Planning - Case Comments

Project Number: PR-2023-009382

Application Number: SI-2024-00739

Project Name: City Multigenerational Center at 10751 Cibola Loop NW

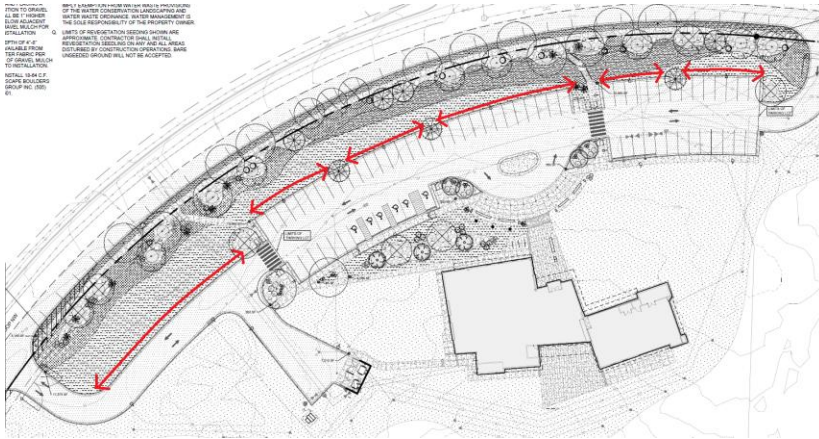
Please demonstrate compliance with this code.

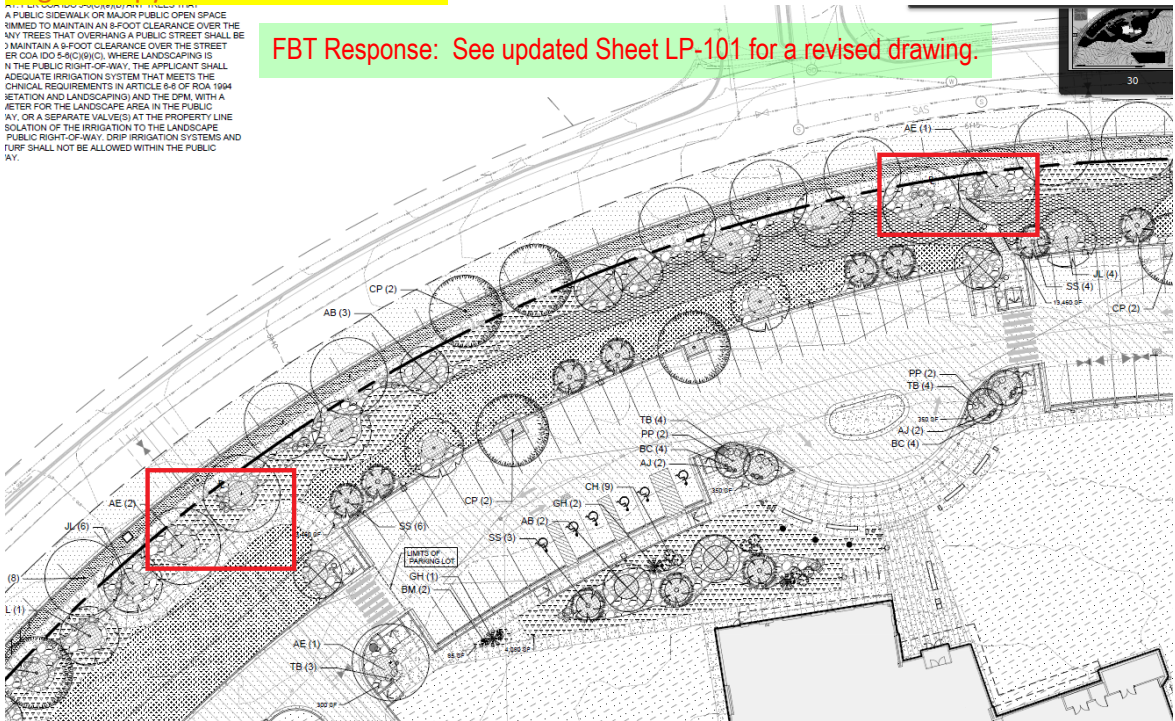
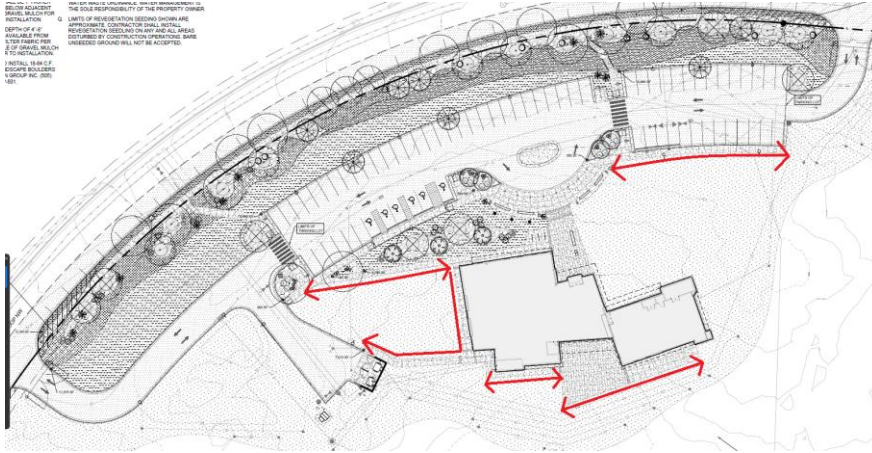
- Change the marked-up trees to provide a break between similar tree species. Please use large canopy trees like Hackberries.

FBT Response: See updated Sheet LP-101 for a revised drawing.

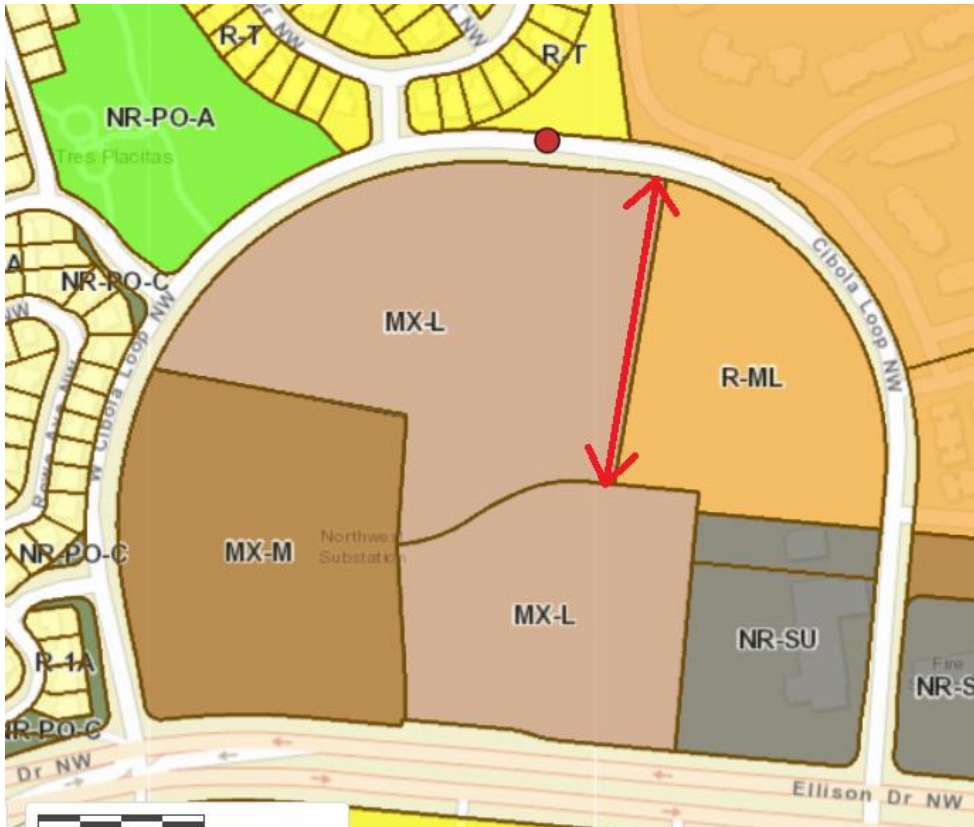
- Cibola Loop separates the parcels from low density residential areas, so no landscape buffers appear to be required along that edge.
- 20' Landscape buffer is required along the edge of the lot abutting the R-ML lot.

The R-ML lot is an undeveloped, city owned property that is not planned to be housing. See current master plan for proposed use(s).
